Proposed Motorway Service Area Development,
M69 Junction 1, Hinckley

Technical Note

Report Number:	3711622-TN
Report Title:	Technical Note – Appeal Statement, Proposed Motorway Service Area Development, M69 Junction 1, Hinckley
Client:	Welcome Break
Date:	10 April 2024
Status:	-

Figure 2.1: Annual Average Daily Flows for DfT Count Point 46056

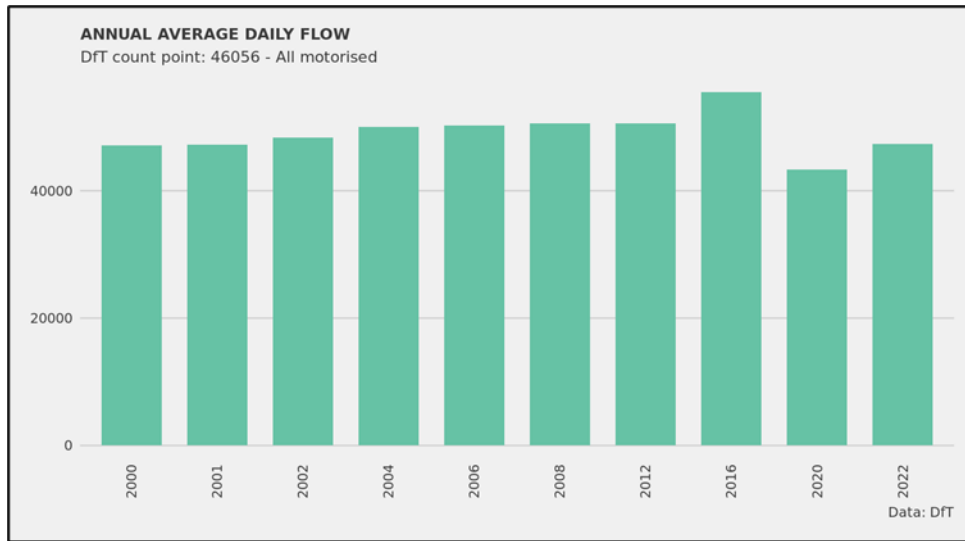
- 2.11 Given the protracted length of time in which it has taken for NH to provide a series of consultation comments over a 10-month period, more recent data is now available, with a new count for 2022 for this count point released by the DfT.

- 2.12 The 2022 data indicates a reduction in flows on the M69 in this location in comparison to the estimates made by the 2019 data. The below figure shows that the DfT data recorded an abnormally high count in 2016, which reduced during Covid and then stabilised during 2022. Therefore, the 2022 data better reflects the average daily flows in this location. It is noted that this data represents a more recent set of data from the source already agreed as suitable for use in the parking assessment by NH.

Figure 2.3: National Highways Regions Map

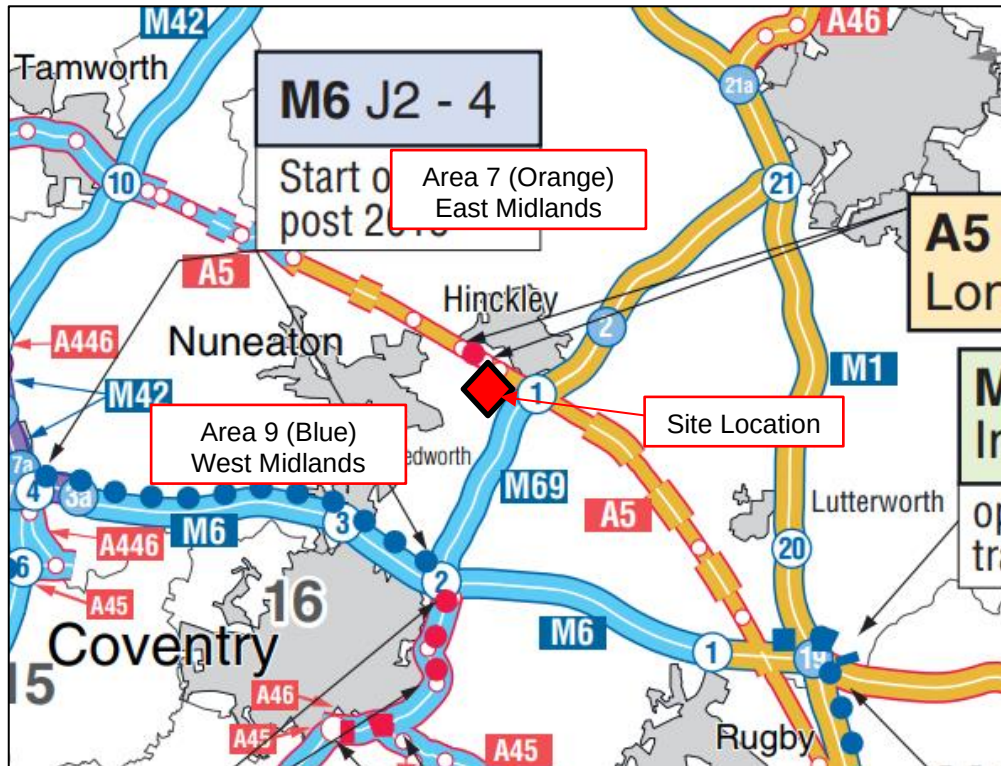
- 2.16 It is not made clear within the report from where this data is derived, however it appears to be based on a series of snapshot surveys undertaken on nights during March 2022. The study is not clear on its methodology in terms of the locations of the sites surveyed, or any comparative analysis on this point.
- 2.17 Moreover, the application site is a cross-boundary application which crosses both the East and West Midlands. **Figure 2.3** illustrates the site location in relation to NH's map denoting their Areas 9 (West Midlands) and 7 (East Midlands).

- 2.18 Indeed, the site would primarily cater for eastbound traffic from the M69, coming from the West Midlands, with the HGV parking area itself also located within the West Midlands (within Rugby Council land, who are the lead authority in relation to the application).

- 2.19 Therefore, there would be no requirement to provide double the number of HGV parking spaces on the site, which is also an unfeasible request given the constraints of the site. However, it is acknowledged that some of the site is situated within the East Midlands and that the site may also cater for some traffic heading westbound on the M69 from the East Midlands.

Proposed Site Layout - Scale 1/2000

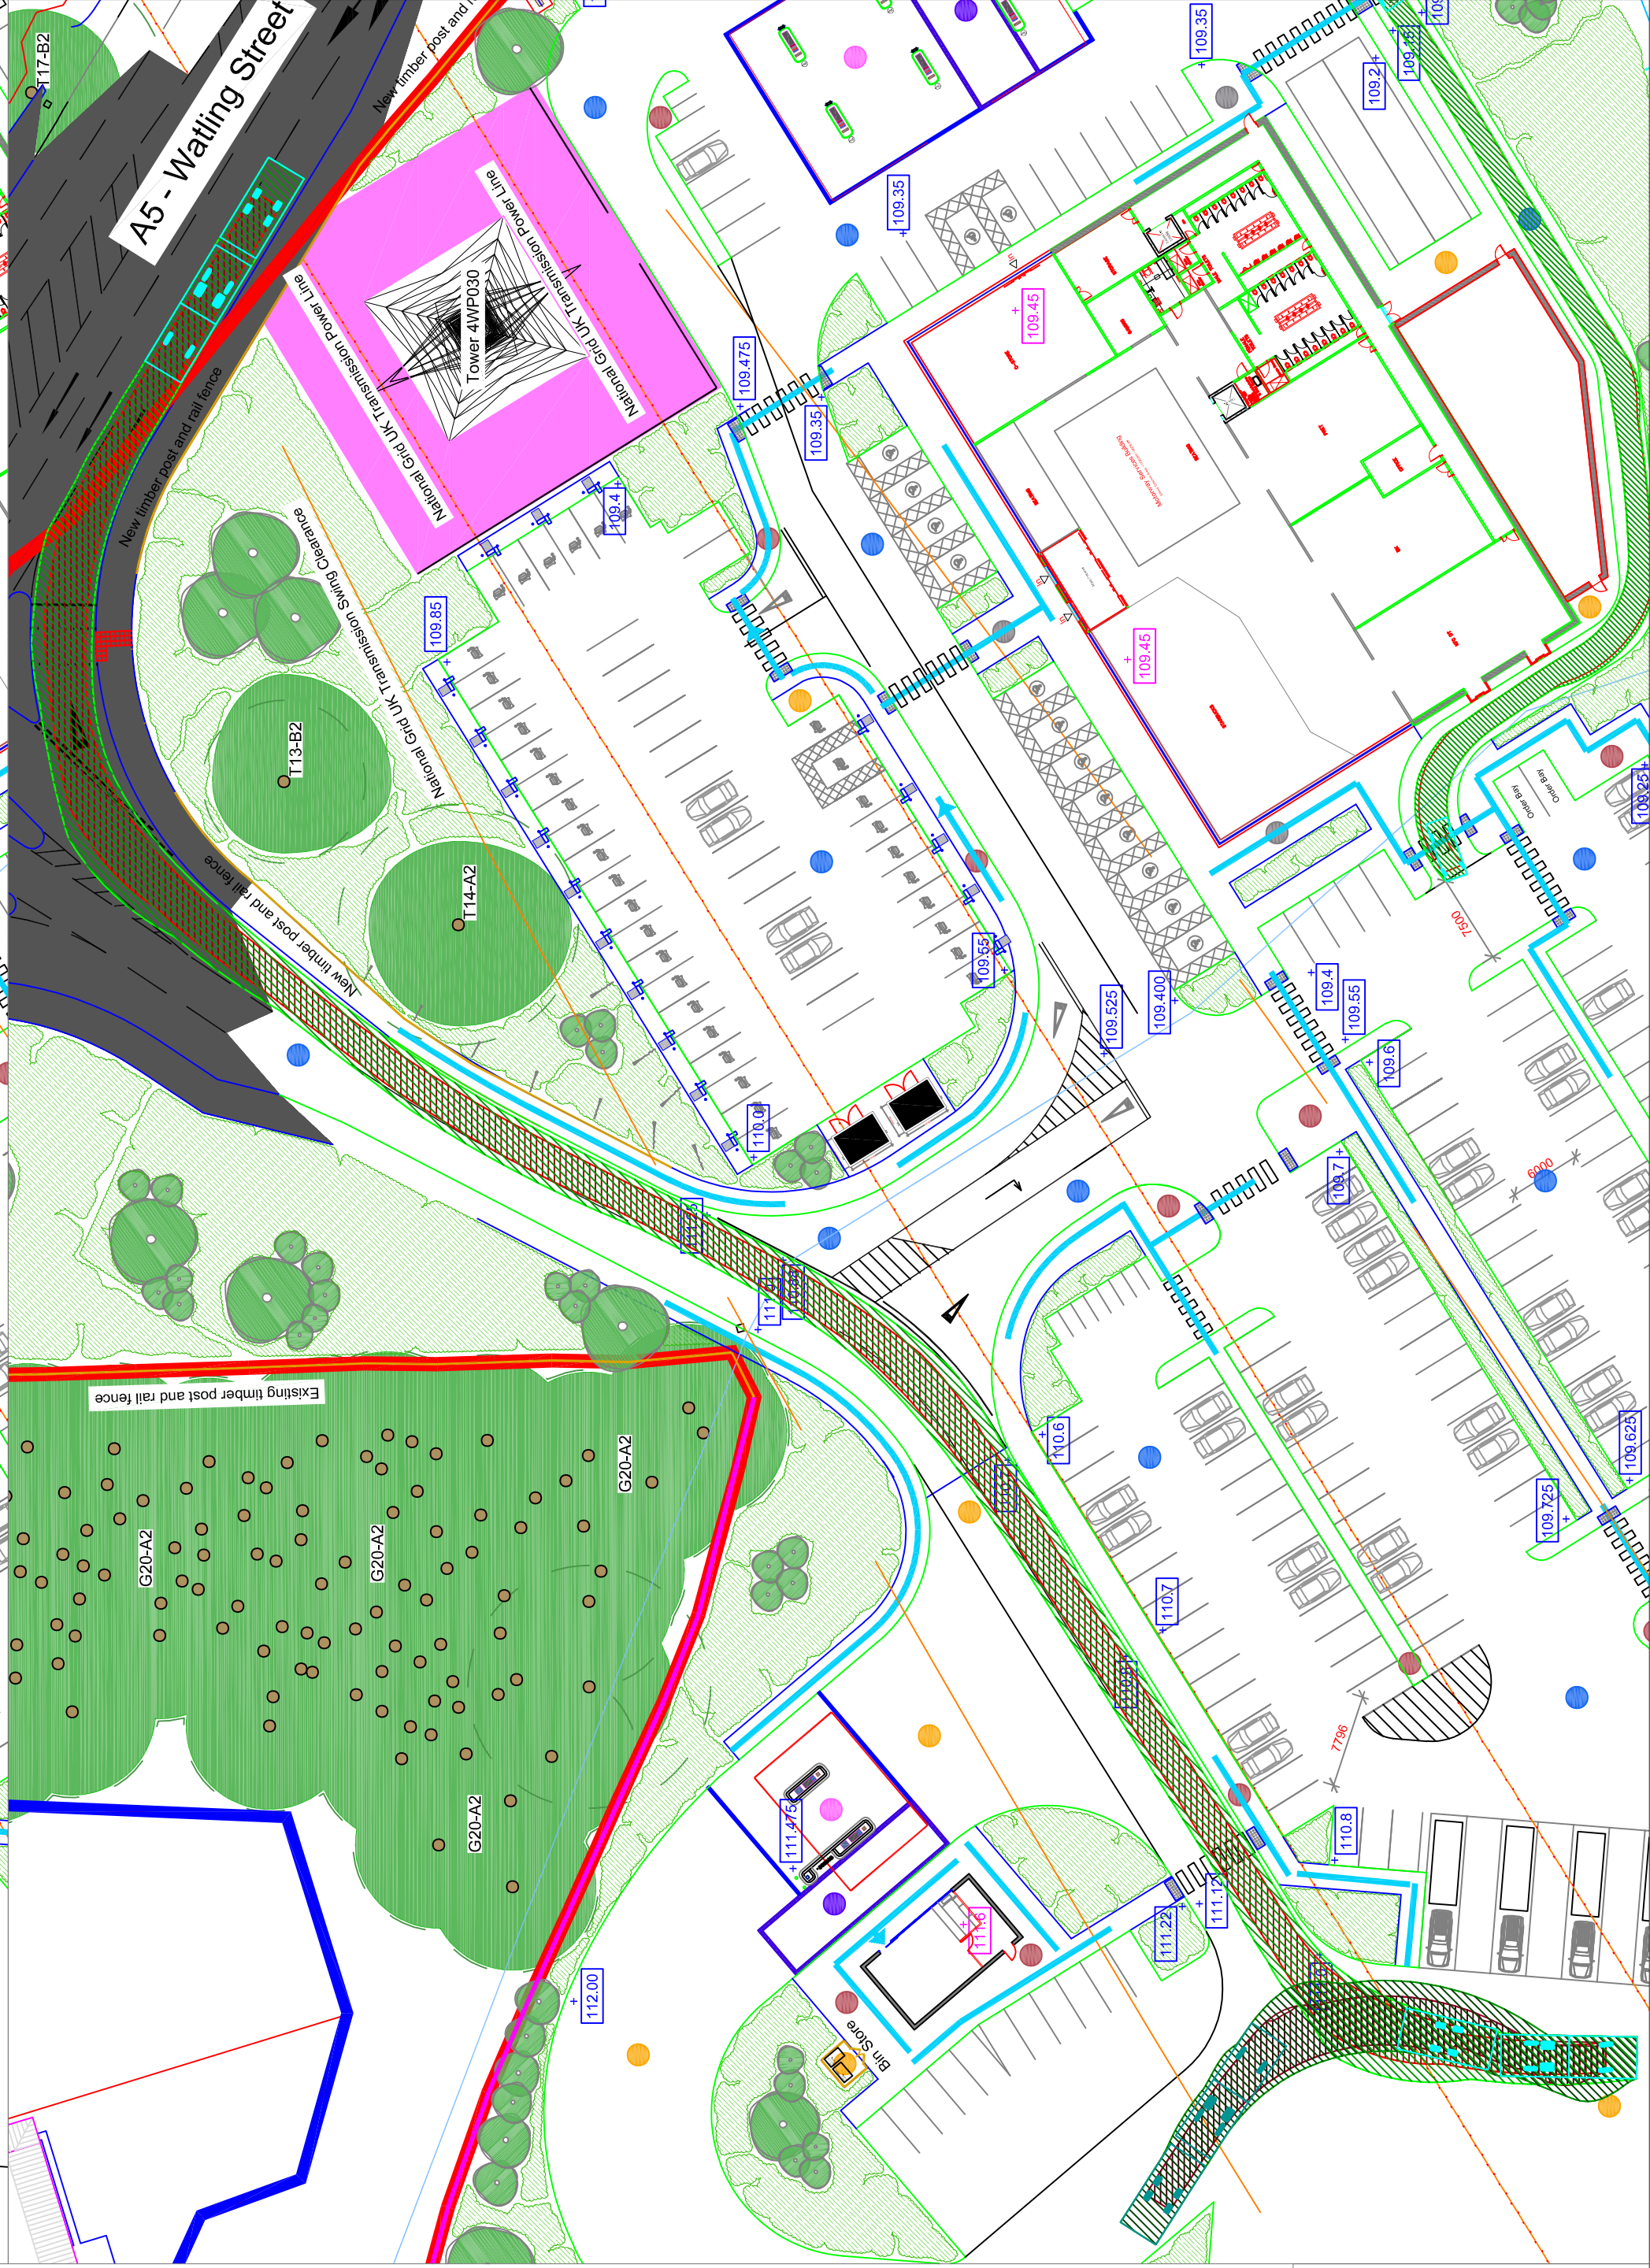
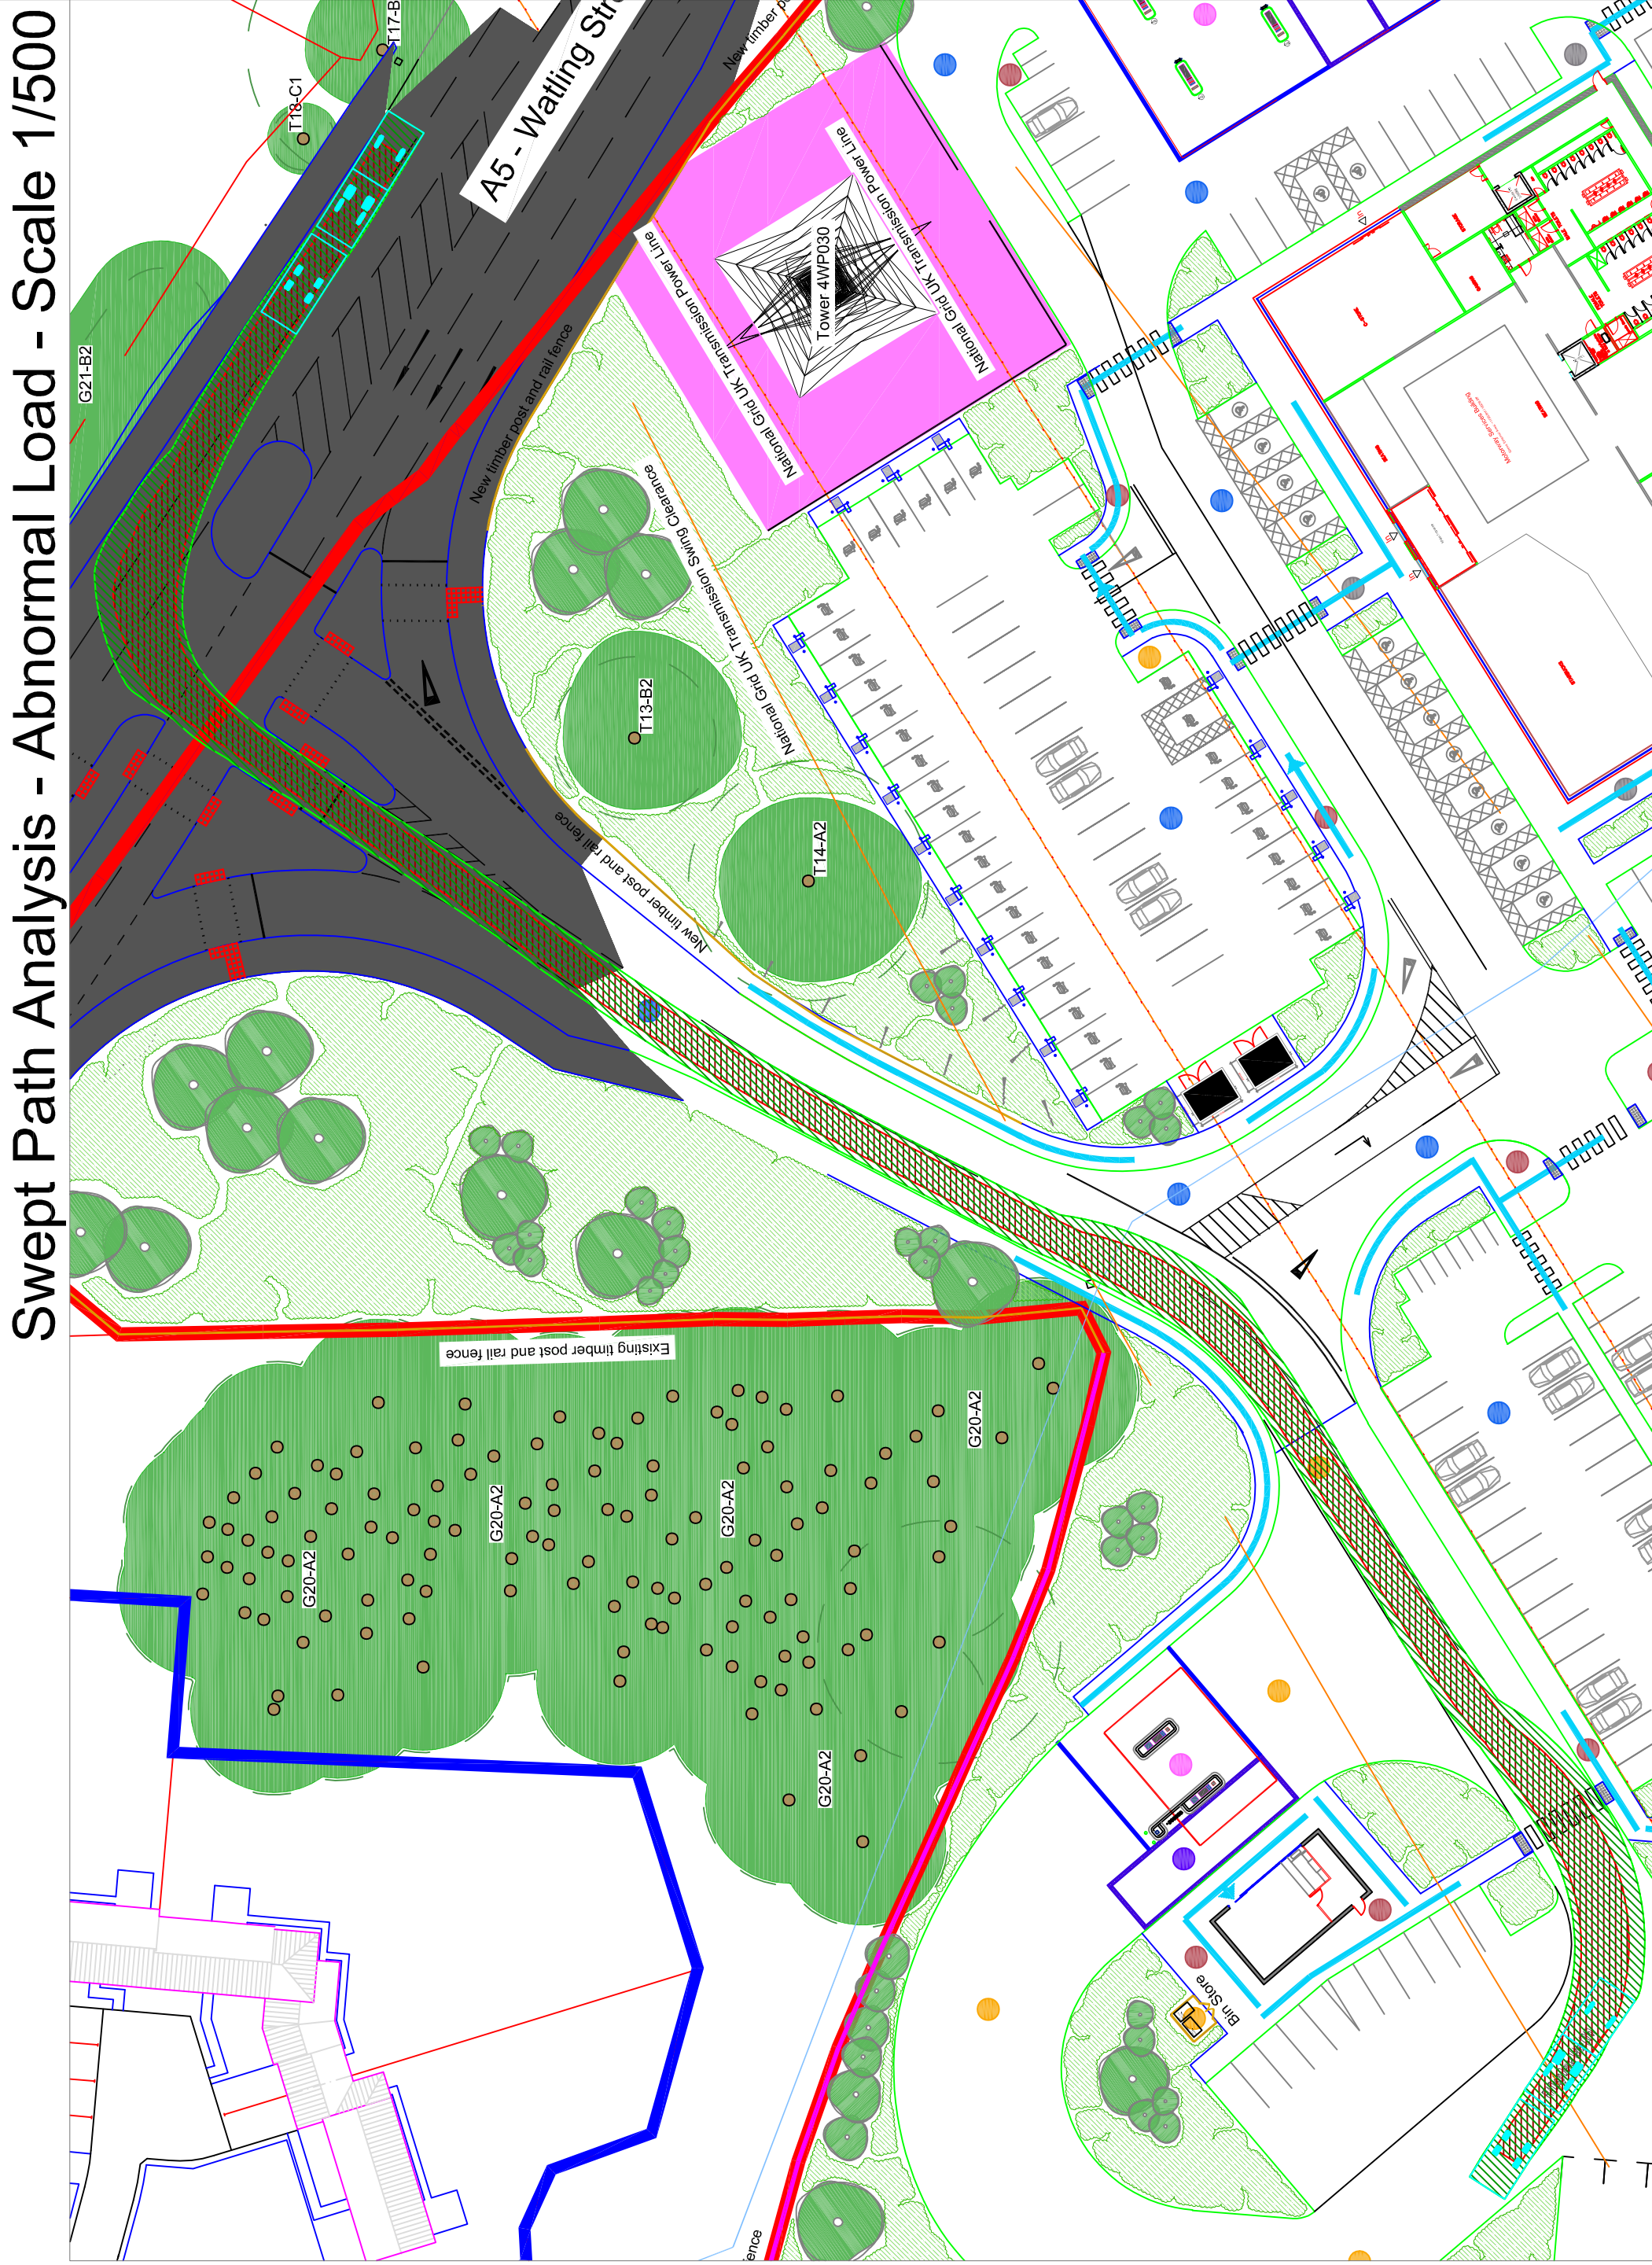
The proposed Site Layout Drawing (ref 1415-23 revision K) indicates the site layout including access point, amenity building, drive through, parking areas, and HGV fuelling area. It is believed that the fuelling area for domestic vehicles is located to the southeast of the Site, however, this is not labelled. Given that the provision of fuel is a mandatory requirement for MSAs, the location of this component should be clearly identified.

As above, the Site Layout Drawing should be updated to identify locations for the provision of security monitoring equipment (i.e. CCTV) and lighting.

Finally, it should be noted that MSAs must include parking provision for a least one [abnormal load](#). This provision is not clearly identified on the Site Layout Drawing and not referred to the Transport Assessment.

- 2.7 NH outline that further information is required to demonstrate that the scheme meets minimum requirements for an MSA. These matters are addressed as below:
- Fuel Provision – Now identified on updated site layout plan;
 - CCTV and Lighting – Now identified on updated site layout plan; and
 - Parking Provision – Further discussed in the following section.

- 2.21 This is further considered to be robust as the site located to better serve eastbound traffic and the majority of the site is in the West Midlands. An updated site layout plan is provided at **Appendix 3** which demonstrates the increase in HGV parking on the site, which now satisfies the DfT parking requirements on the above basis.

- 2.25 The same approach was taken on the current proposals, with two HGV bays allocated as an 'abnormal load bay'. However, given NH's concerns, an abnormal load bay has now been provided and is shown on the plan at **Appendix 3**.

- 2.40 In terms of an abnormal load bay, an area has been identified on the updated site layout plan for abnormal loads, with a swept path analysis undertaken for the specification of vehicle requested by NH.
